1986 - 1987 Corvette: Service Bulletin: Clutch Master Cylinder Push Rod Bushing

Bulletin No: 87-114, Section 7C

Date: April, 1987

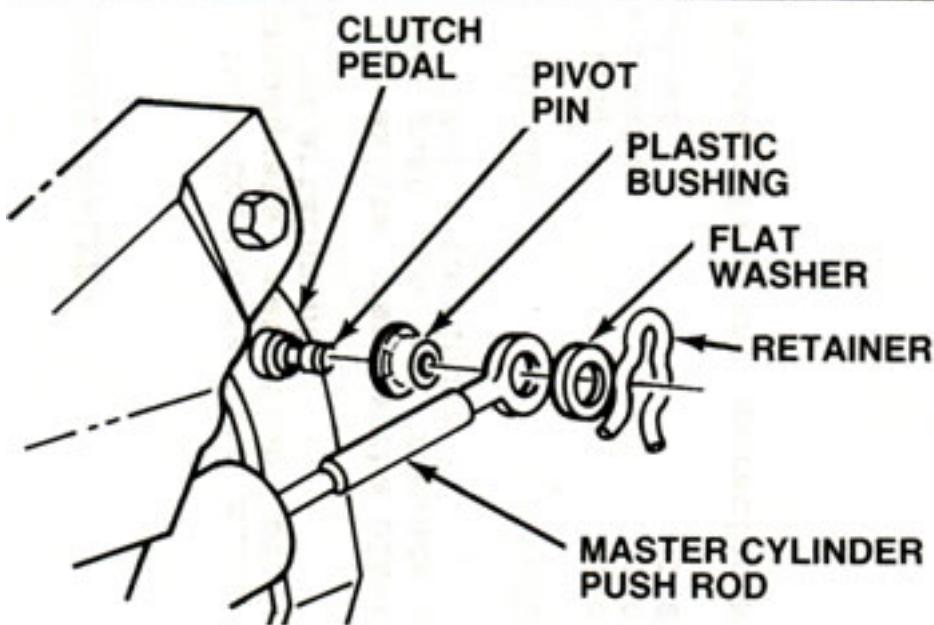
Some 1986 or 1987 Corvettes with manual transmissions may experience inadequate retention of the clutch master cylinder push rod attachment.

If the condition exists, remove the plastic bushing from the master cylinder push rod and replace with the following service parts. (Refer to Figure 1):

DESCRIPTION	PART NUMBER
Bushing	14080233
Flat Washer	120395
Retainer	148149
